MCGOWIN PARK, **RESUBDIVISION OF LOTS 1 & 2**

APPLICATION NUMBER 6 DATE September 18, 2014
 APPLICANT McGowin Park Subdivision, Resubdivision of Lots 1 and 2
 REQUEST Subdivision

DETAIL SITE PLAN

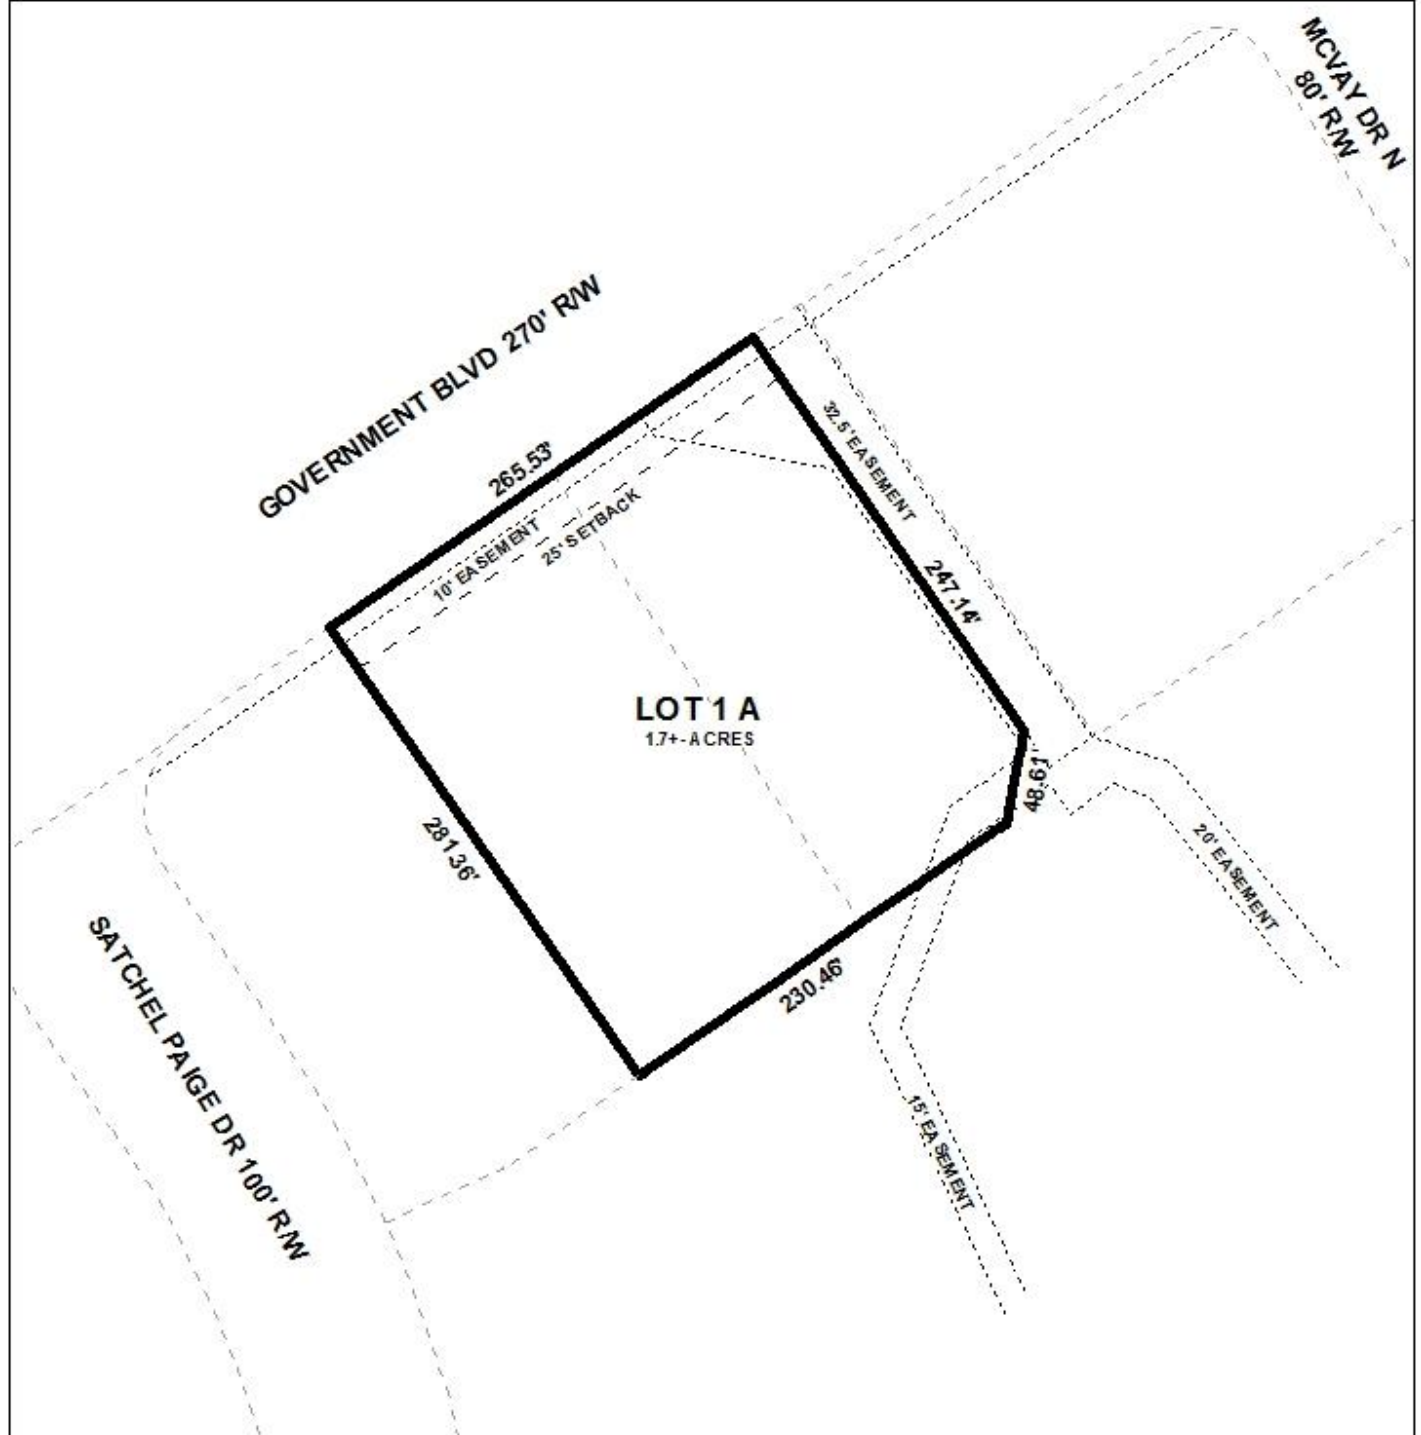
- 1) placement of a note on the final plat stating that the number, size, design and location of any new curb-cuts or modification of existing curb-cuts are subject to compliance with the approved PUD site plans, Traffic Engineering approval, ALDOT approval where required, and to conform with AASHTO standards;

- 2) revision of the plat to depict the 25-foot minimum building setback line;
- 3) labeling of each lot with its size in square feet and acres, as depicted on the preliminary plat;
